## **WAMBO COAL GROUNDWATER MONITORING PROGRAM**

Document No. WA-ENV-MNP-509.1

April 2018

**Figure 5: Location of Alluvium in Lower Reaches of Creeks**

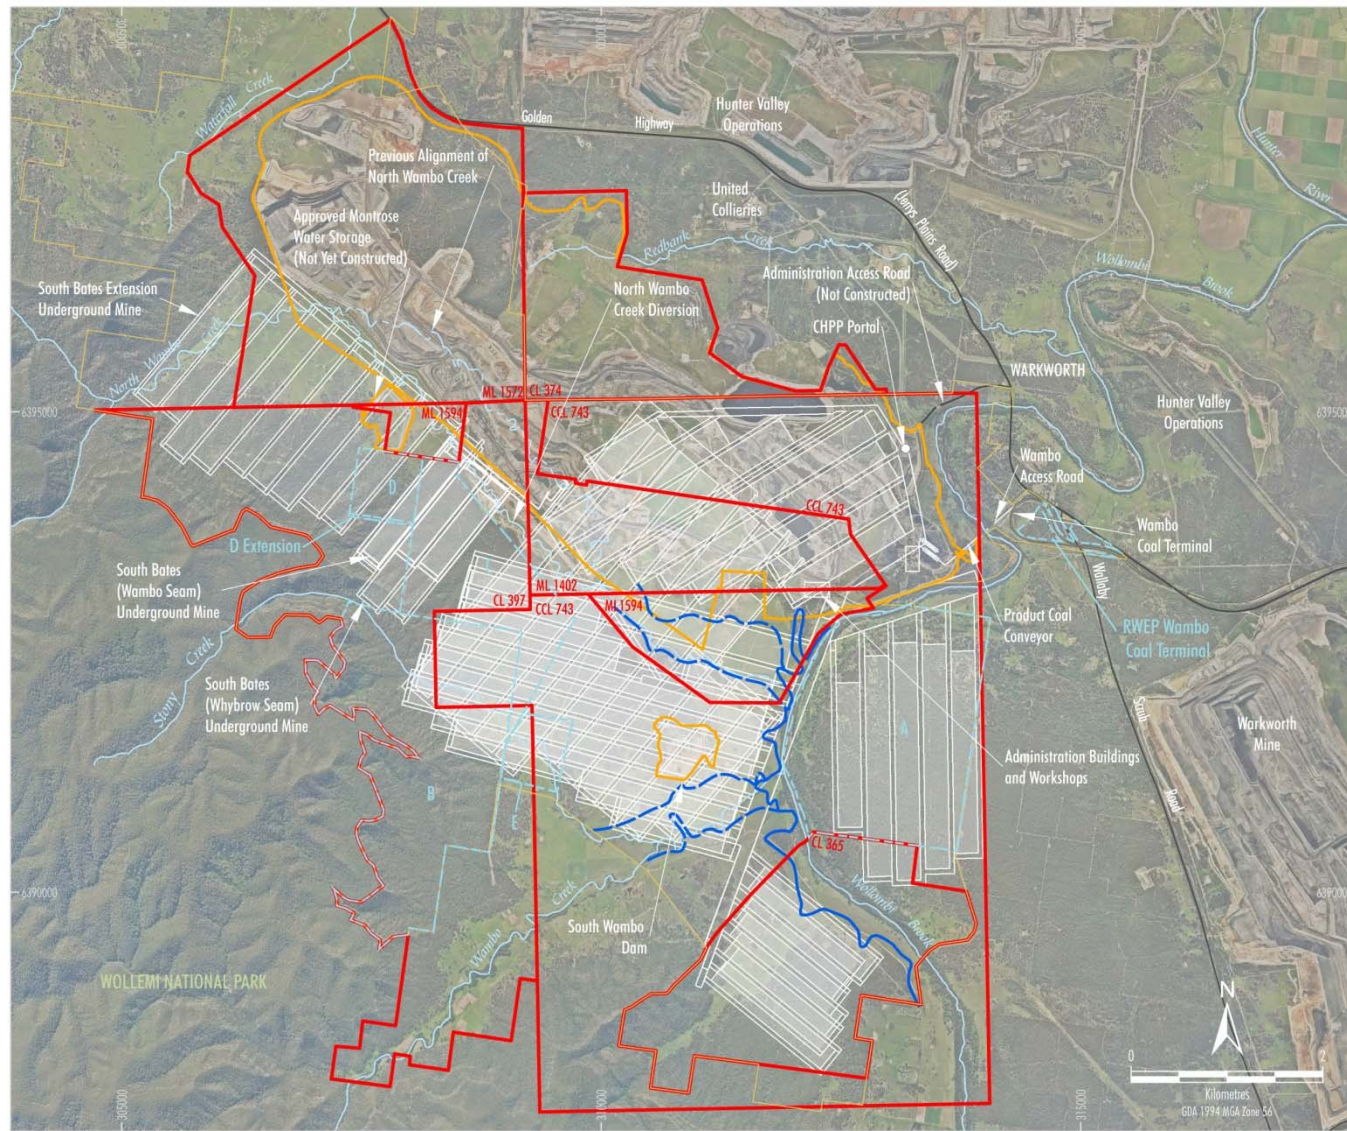
Replace Figure 5 with the location of the approved longwall layout for LWs 11-16.	Figure 5 has been revised to show the location of mapped alluvium in the lower reaches of the creeks over the latest approved underground mine layout.
Update Section 2.2.1 to include a discussion of the latest approved mining operations in the South Bates Underground Mine.	Section 2.2.1 has been revised to discuss the latest status of mining at Wambo.
Update Section 2.2.2 to describe the current groundwater monitoring network. Replace Figure 7 with Figure 4 in Technical Report 2.	Section 2.2.2 has been revised with the latest groundwater monitoring network.
Update the data summaries in Section 2.2.3 (including Table 8) to include the last 3 years of data.	The data in Table 8 (HARTT Analysis Results for Shallow Monitoring Bores) was used to generate the groundwater impact assessment criteria.  It is not considered appropriate to continue to update baseline data during mining operations, as it may skew the impact assessment criteria. Monitoring results during operations are presented in Annual Reviews.
